TO: Laramie County Board of Commissioners
FROM: Marissa Pomerleau, Planner
DATE: February 2nd, 2021
TITLE: PUBLIC HEARING AND POSTPONEMENT REQUEST regarding a Subdivision Permit & Plat for Meadowlark Airpark, located at Govt. Lots 1, 2, 3, and 4 less a portion, and all of the NW1/4 SE1/4 less a portion, Sec. 6, T.14N., R.64W., of the 6th P.M., Laramie County, WY.

PZ-20-00330

> FINAL PLAT FOR MEADOWLARK AIRPARK

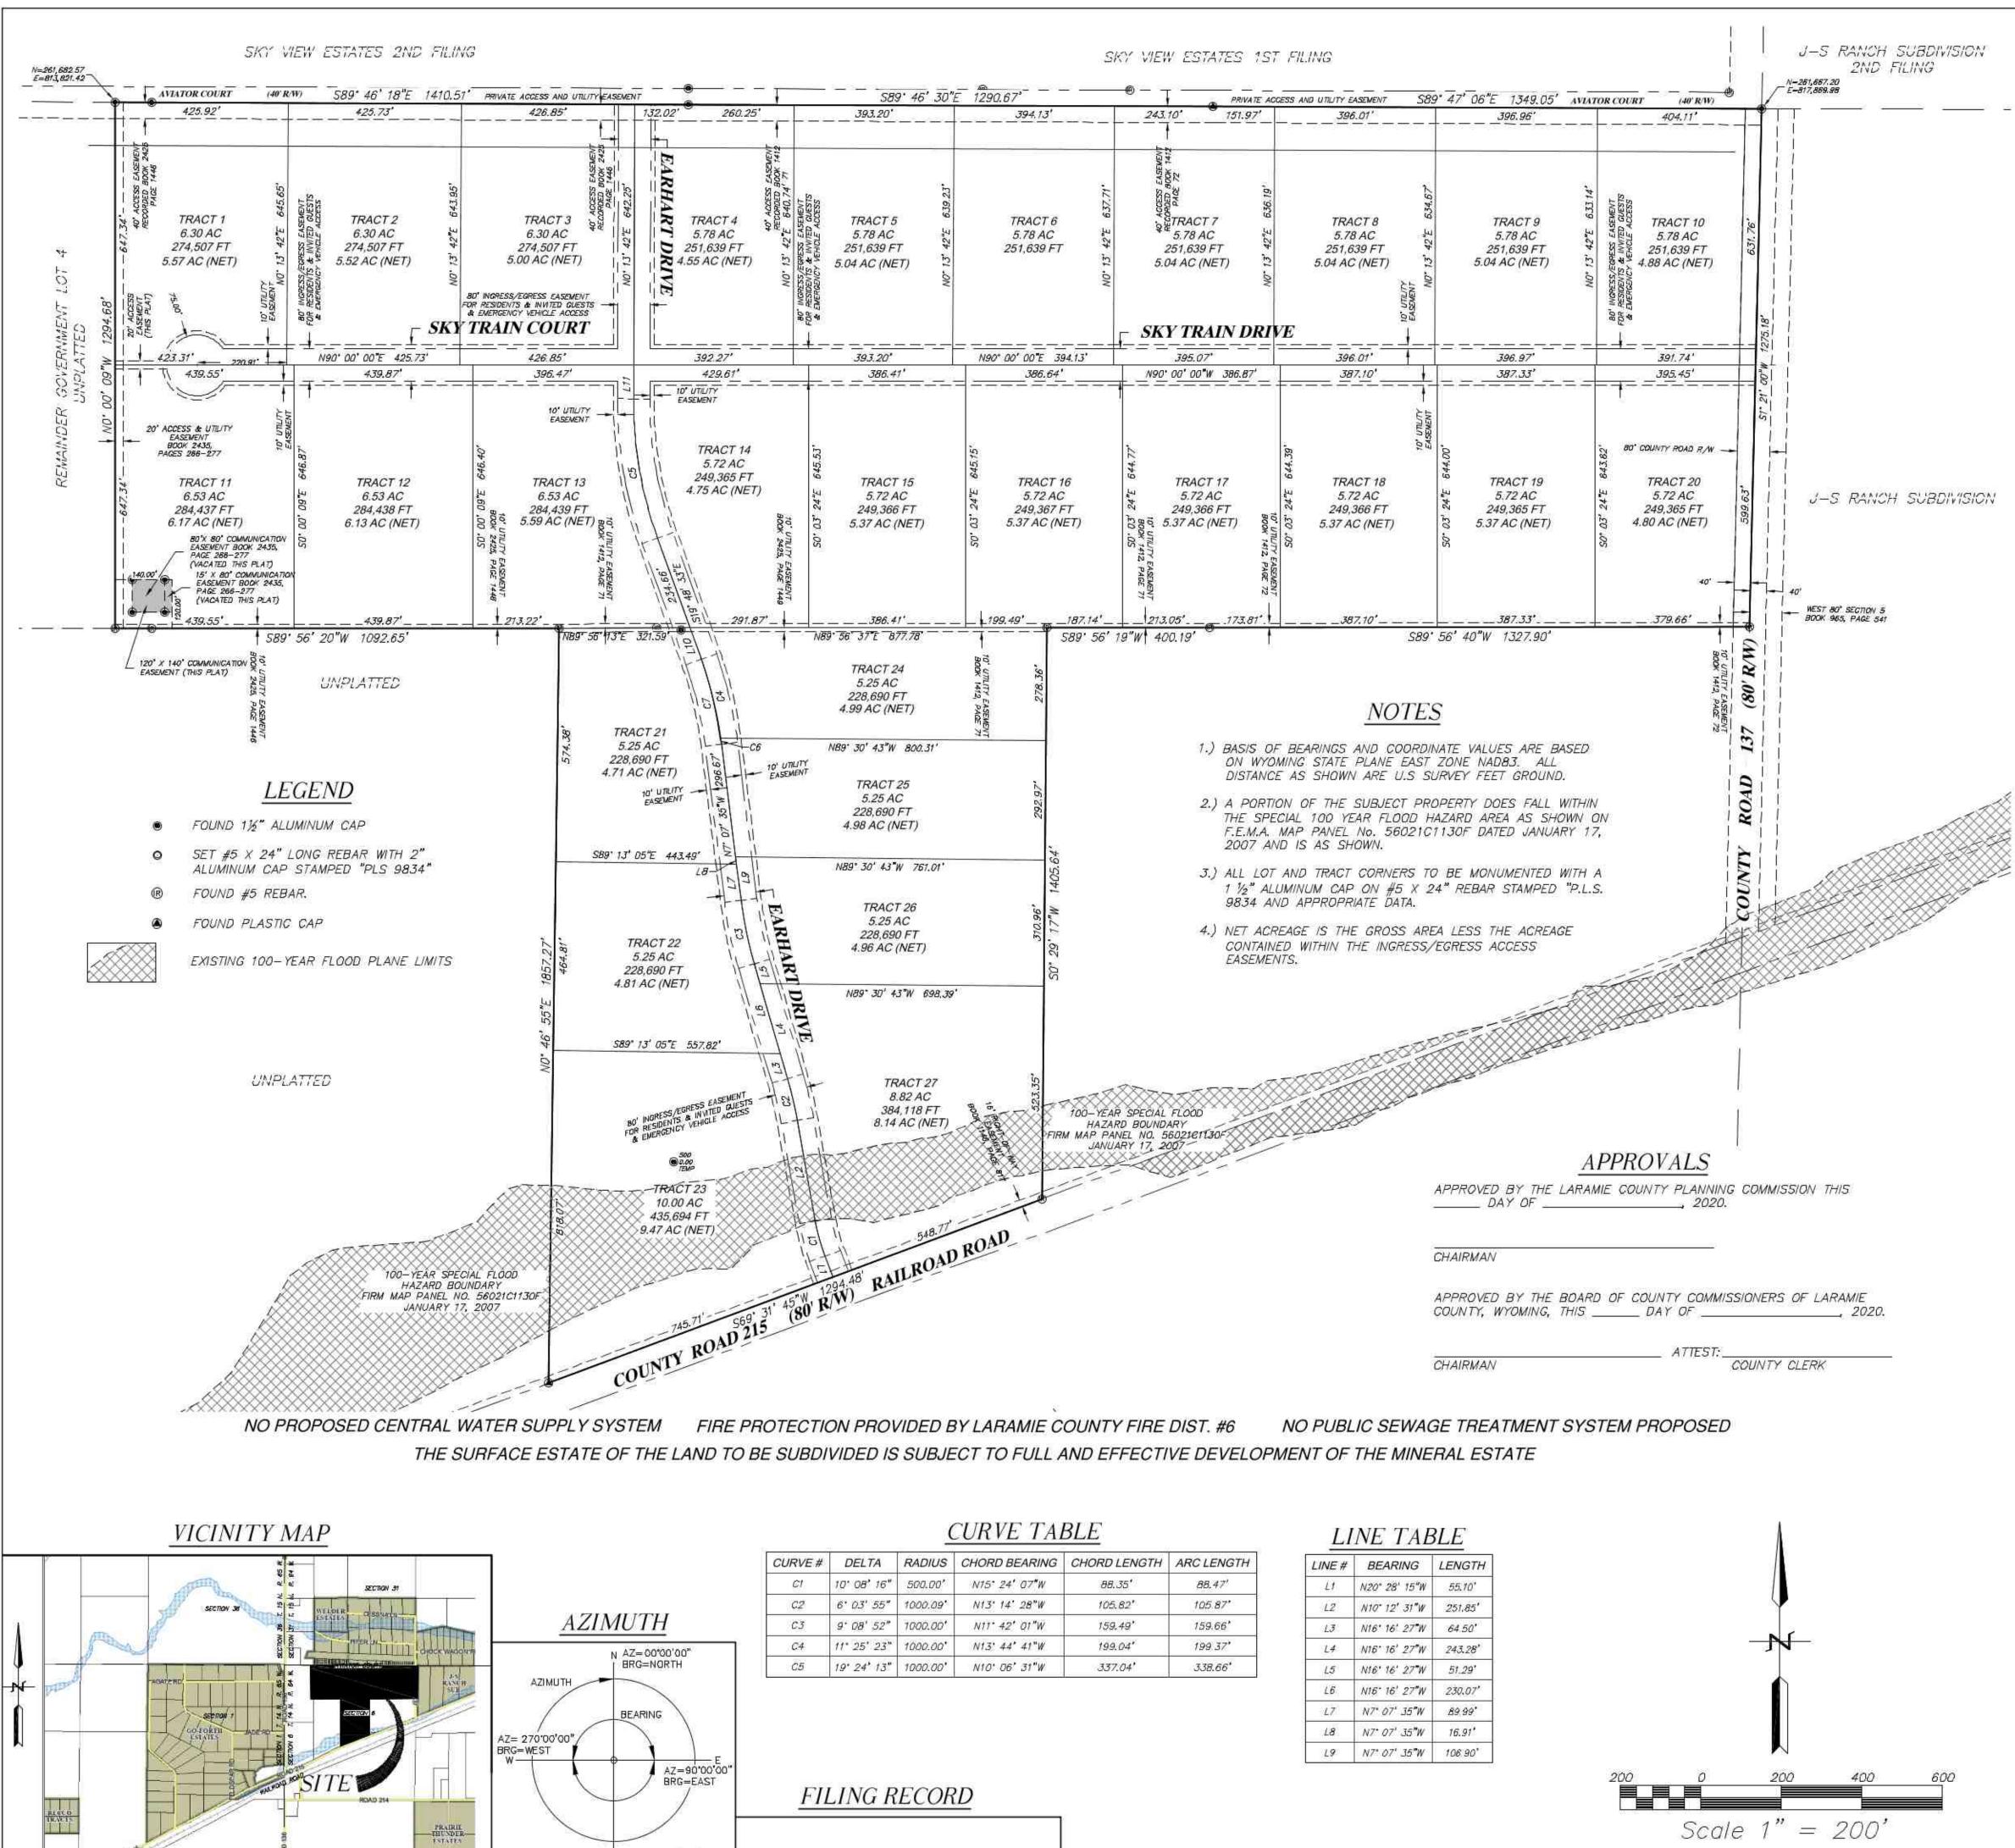
<u>County Assessor:</u> County Assessor, Kaycee Eisele Comments Attached 12/28/2020 In the title block, Airpark is one word, which is what our records will reflect but in the dedication it is 2 words.

4. The Curve Table on the plat does not show the information for C6 and C7 that are called out on the drawing.

5. The Line Table on the plat does not show the information for L10 and L11 that are called out on the drawing.

6. The dates on the plat for approvals show 2020 and these should be changed to 2021.

1. In the first line of the last paragraph of the DEDICATION "HAS" should be "HAVE", in the second line of the same paragraph "THERE" should be "THEIR" and in the third line of the same paragraph "THERE" should be "THEIR".

The dimension arrow indicating the north boundary of SKY TRAIN COURT, shown along the south boundary of TRACT 2, is drawn/connected to the north boundary of the 10' UTILITY EASEMENT, not to the north boundary of SKY TRAIN COURT.
 Along the east boundary of TRACT 4, the text identifying the 40' ACCESS EASEMENT is overlapping the dimension of the east boundary of TRACT 4.
 What is the purpose/function of the "WEST 80' SECTION 5-BOOK 955, PAGE 541" labeled east of the southeast corner of TRACT 20?

1. In the first and fourth paragraphs of the dedication, the subdivision is referred to as "Meadowlark Air Park", but in the title is is referred to "Meadowlark Airpark". Please revise.

2. The third paragraph of the dedication should also be updated to say "Said parcels" not "Said parcel".

3. The approval blocks must be placed directly next to the right or bottom border of the plat.

4. Approval Dates in the signature blocks must be updated to read 2021 rather than

5. Please label the property directly to the east of proposed tracts 24-27 as unplatted for continuity purposes.

6. Please add a note stated that the proposed roads will be privately maintained and will not be maintained by Laramie County.

7. Please update the Curve and Line Tables to show all Curve #'s and Line #'s as some are missing.

8. The acknowledgments signatures block will be signed in 2021, please update year.
